URBAN DESIGN CONSULTATION RESPONSE

Design Officer	Azhar Kapadi
Date	17.04.26
Application Reference	25/00405/FUL
Address	Land South Of Greenvale, Bamford, Rochdale
Proposal	Demolition of existing dwelling and construction of a residential development for 43 no. dwellings with access and associated works

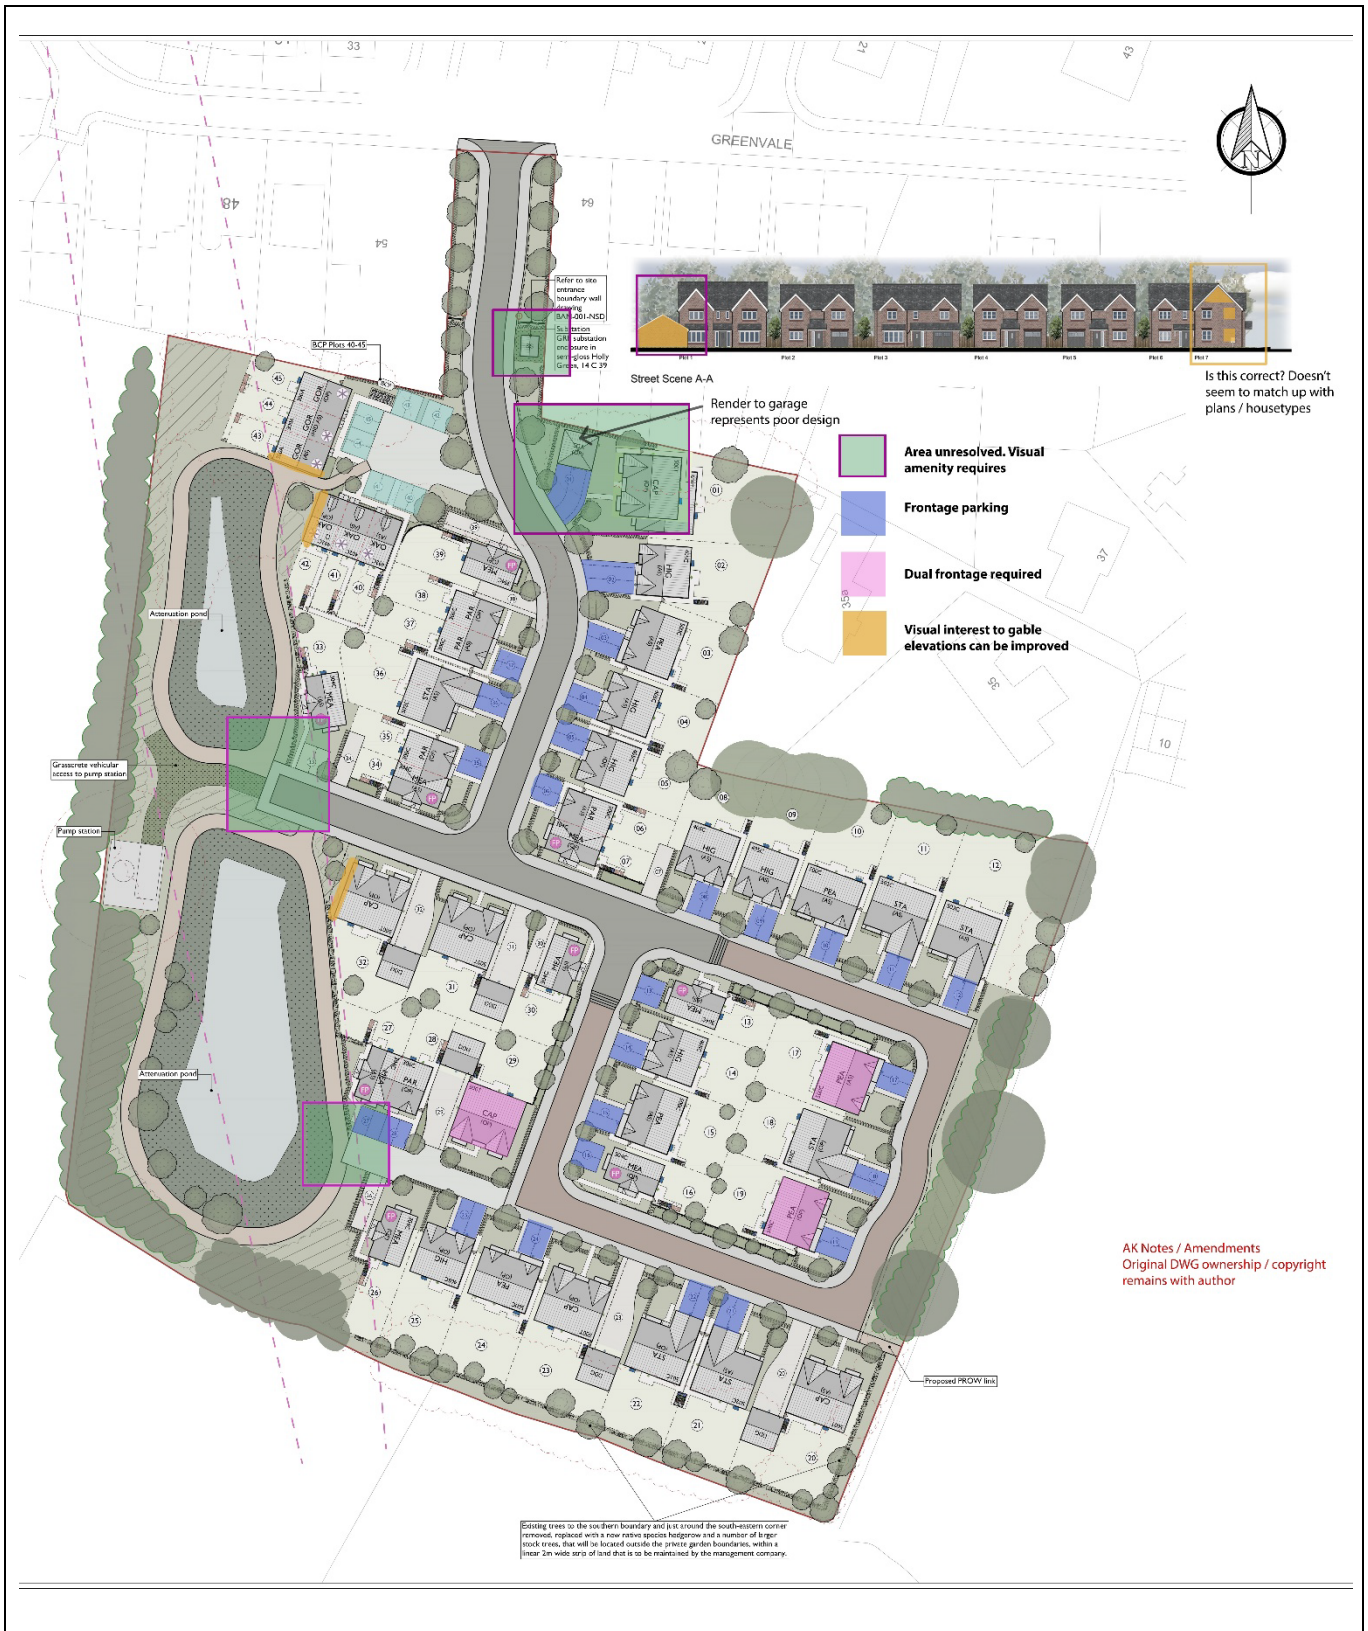
There are concerns regarding the visual amenity of the site entrance. The substation is overly prominent and would benefit from improved screening, such as hedge planting, to better integrate it into the streetscape.

Plot 01 has an awkward access arrangement that is unnecessarily dominated by a large garage and parked vehicles. This could be resolved by repositioning the dwelling and incorporating a single side garage, resulting in a less cluttered frontage and a larger, more usable rear garden.

In addition, the use of render to the garages, aside from the front elevation, is poor design practice. Render has limited durability and weathers poorly, particularly when set against brick and stone. Its use in this context weakens the overall quality and cohesion of the development and does little to enhance its appearance. This affects Plot 01 more than Plot 20/23 due to visibility.

The footpath arrangement around the SuDS area appears unresolved where it meets the highway. In particular, there is a conflict between the footpath and the access road to Plot 27, which requires reconsideration.
